**2025 Amendment to the 1986
Mt Van Hoevenberg Intensive Use Area
Unit Management Plan**

Proposed Final

December 31, 2024

Figure 17

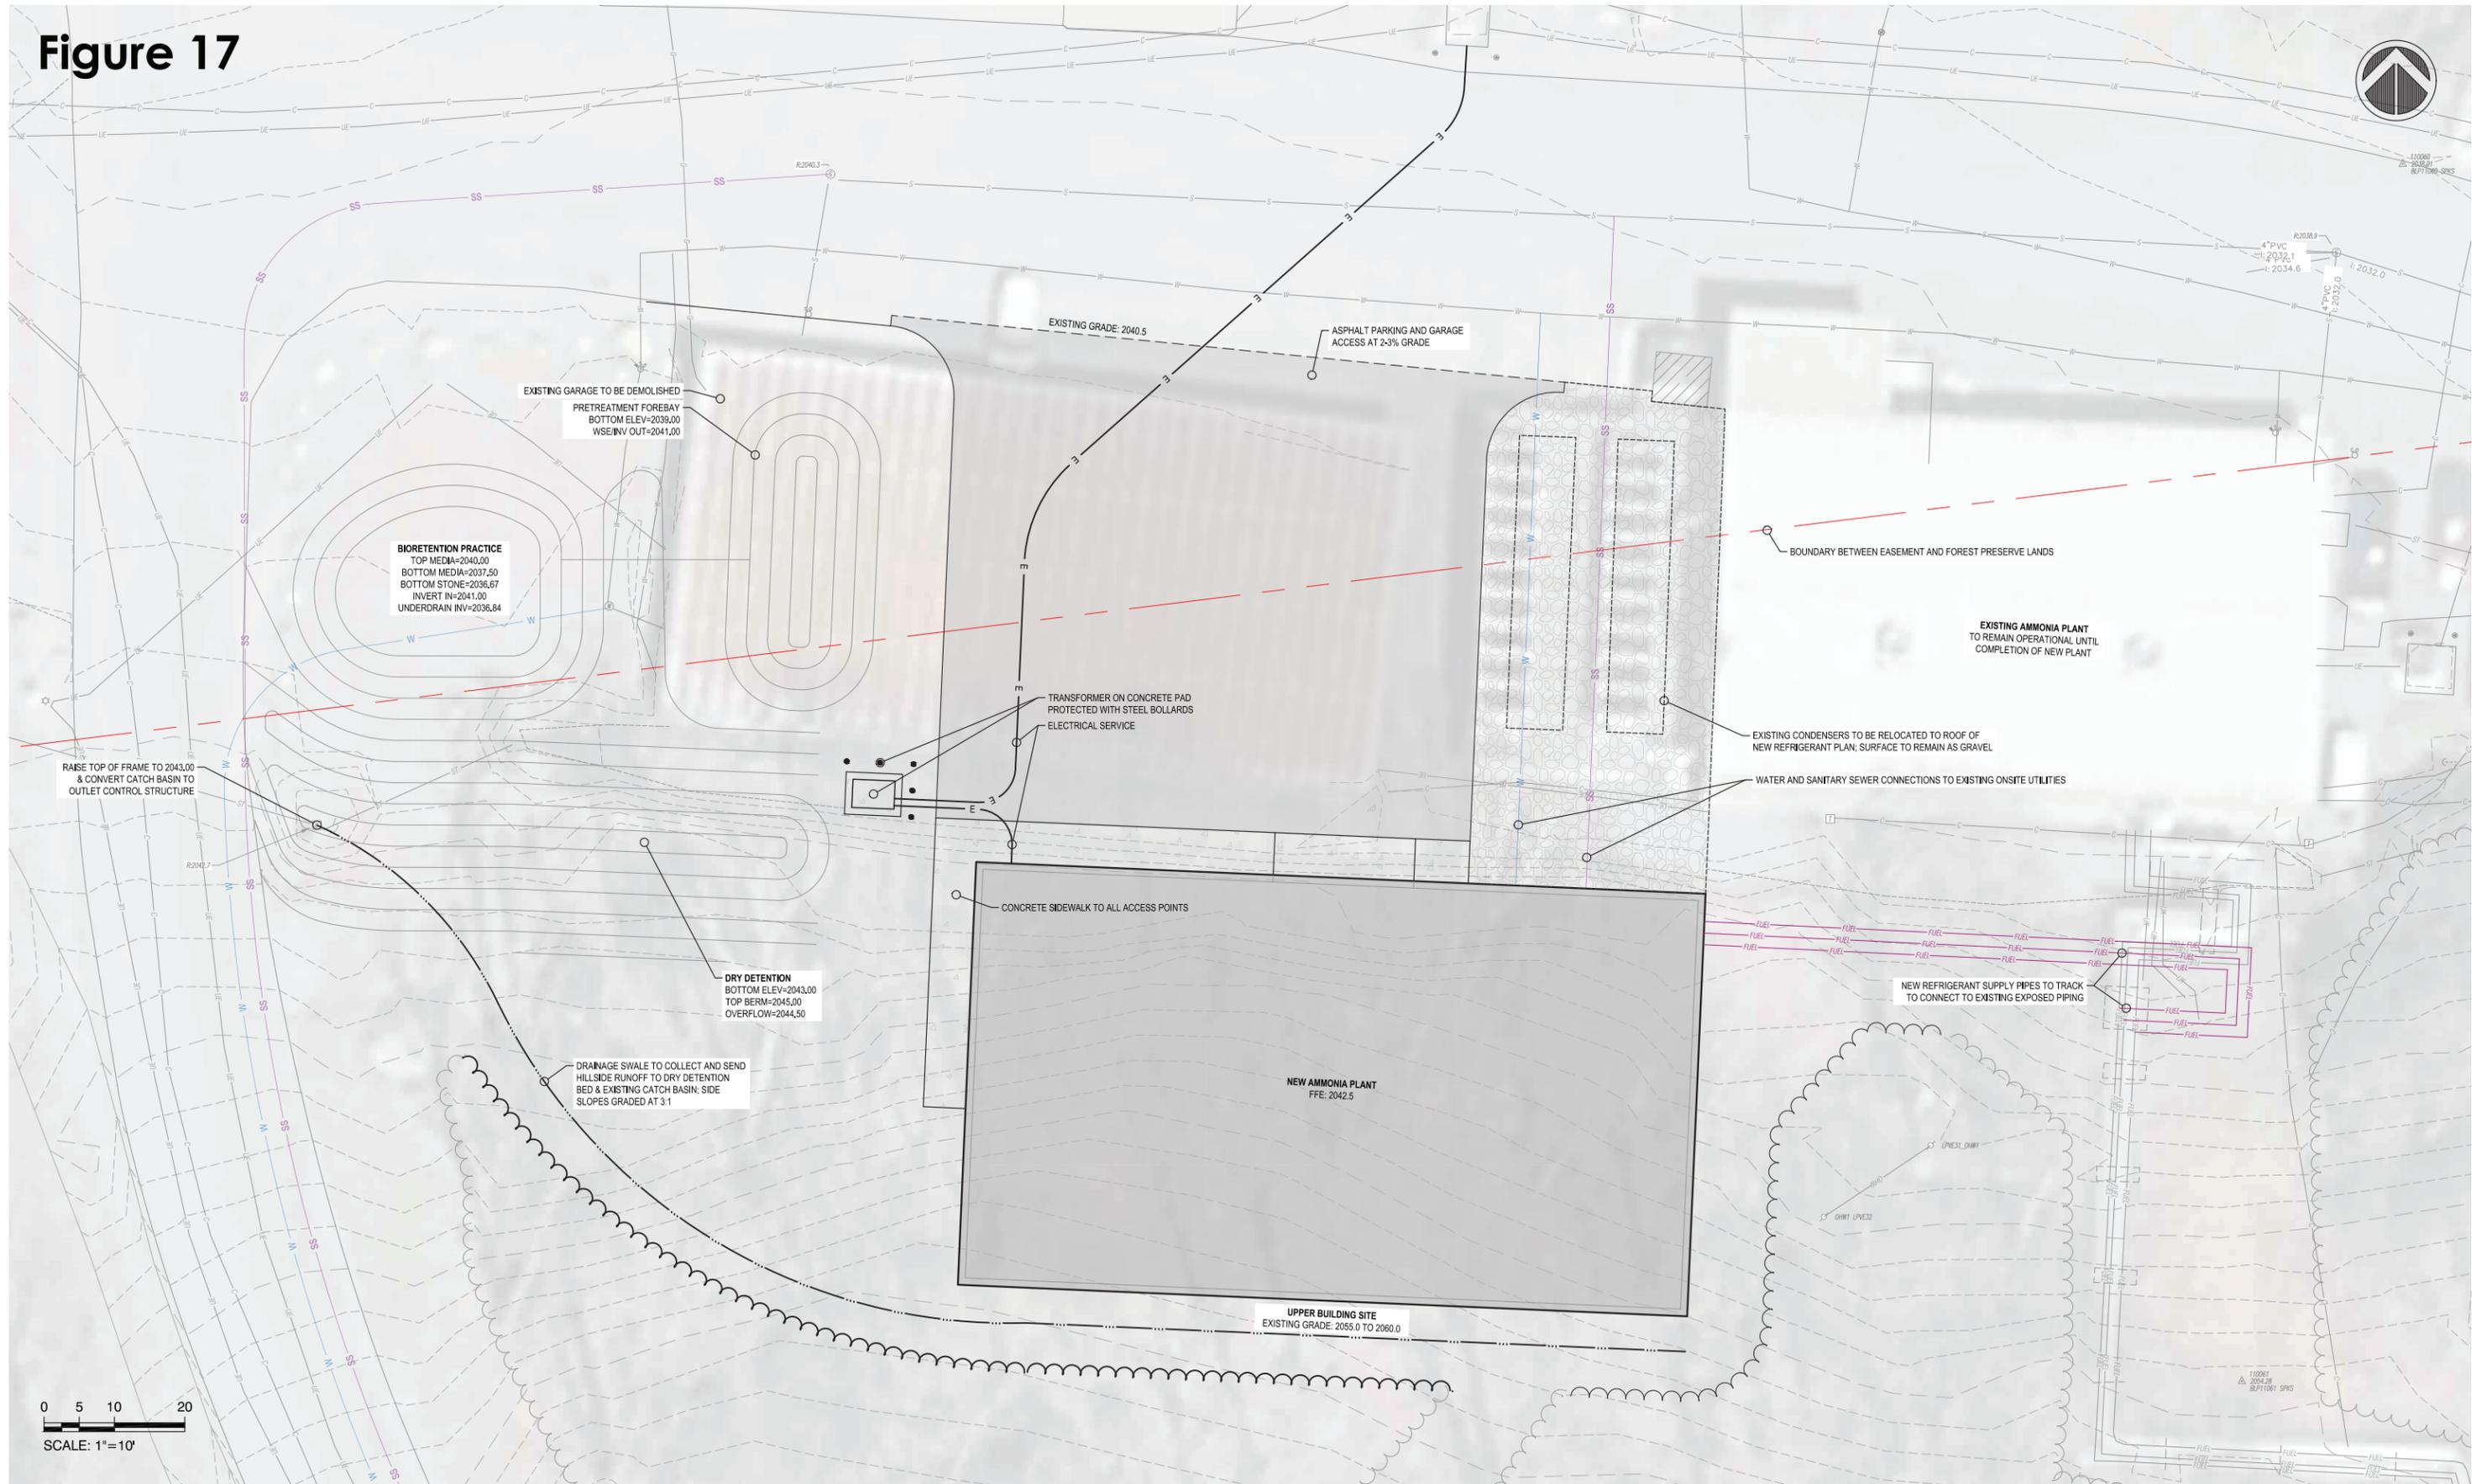
Response: *The Unit Management Plan Amendment proposes the extended utility lines will utilize the existing footprint of a driveway and location of the existing condensers that will be relocated. Figure 17 depicts the location where underground utilities will go.*
